## Downtown Development Review Overlay (DDRO) District

# MEMORANDUM

**Case No:** 22-OVERLAY-0028

**Property Address:** 133 W. Market St.

Currently Proposed Design – Main Corner of 2<sup>nd</sup> & Market

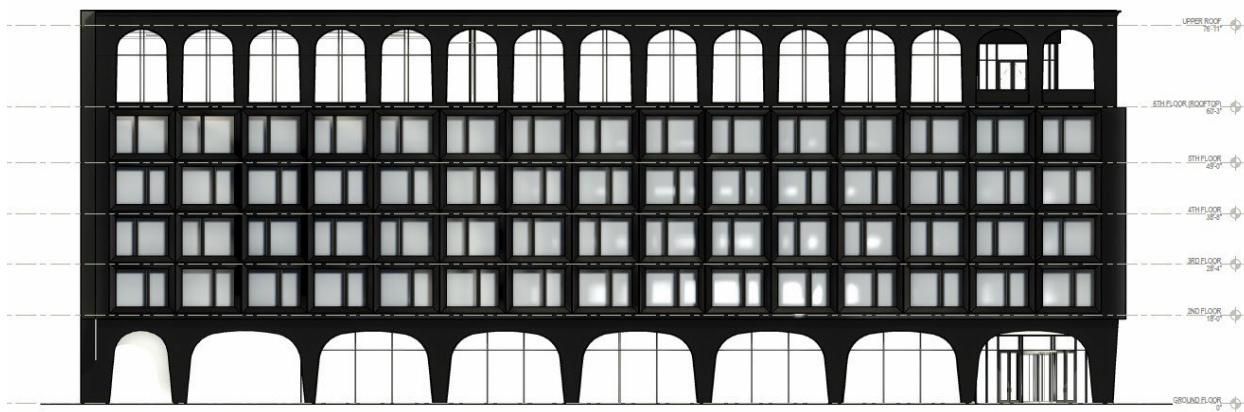
However, there has been a loss of definition for the main corner of the building and defined articulation at the pedestrian street level, that was more discernible in the approved design. The approved design provided visual weight at the corner, through a change in height, slight wall projection, and change in material. This added emphasis and weight clearly identified the main entrance and provided a better spatial relationship with the Convention Center across the intersection. From several vantages, it also helped to break up the overall massing and flat planes of the upper stories.

With the proposed design, the corner is no longer easily discernible from the rest of the building. The height is now uniform across both street-side facades and there is no significant material change. The repetitive arches along the top and bottom continue along the full lengths of each street-side façade, which removes some of the articulation provided by the previously angled walls. While the previously proposed angle visually breaks up the massing and more strongly establishes the corner entrance, the arches at the top and bottom of the building improve the pedestrian experience and result in the building being more dynamic and interesting with varying window forms. The upper arches are slightly stepped back which helps break up the massing along the horizontal. Ultimately, the introduction of the arched openings provides more architectural deviation and makes the building more unique from other buildings downtown. However their

placement along the entire lengths of the façade minimalizes the important corner and establishes a more uniform height. If the changes are approved, attention should be paid to highlighting the corner through other non-architectural means, such as signage, lighting, and/or public art. Entrances should be emphasized with lighting and doorway/storefront features that are distinct from other areas along the ground level. If specific treatments are given in the finishing details, the massing could be better broken up and the corner/main entrance given more emphasis:

8. **Prior to occupancy, finalized design details and materials shall be submitted to Planning and Design Services staff for final review and approval to address the issues with corner of the building and street-facing entrances as described in this report**

Currently Proposed West Façade – 2<sup>nd</sup> St.

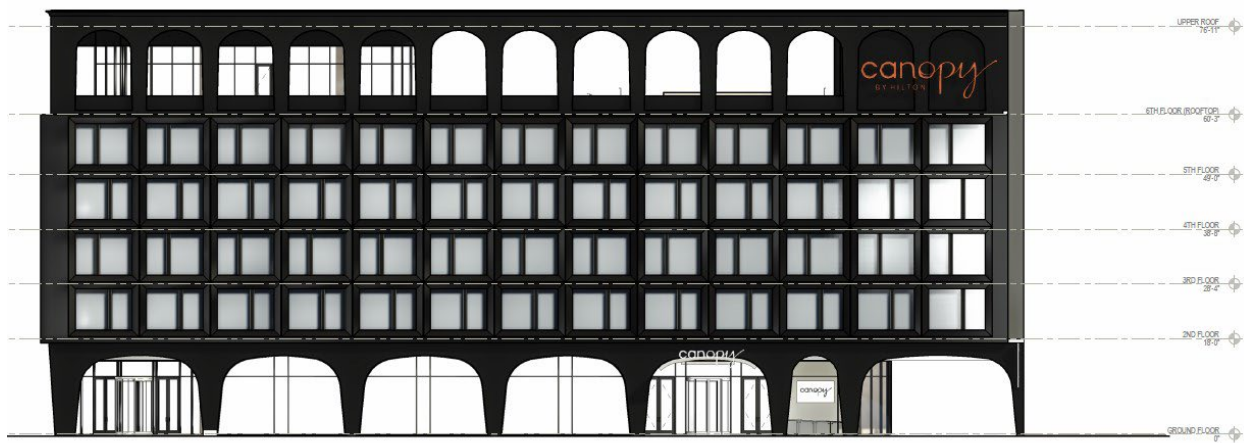
The general massing and height of the building remains relatively the same. The proposed changes introduce a greater amount of storefront glass at the pedestrian level along 2<sup>nd</sup> and Market Streets. The number of upper story window openings are generally the same, as well as their sizes and proportions; however the top story openings have been modified with arch tops.
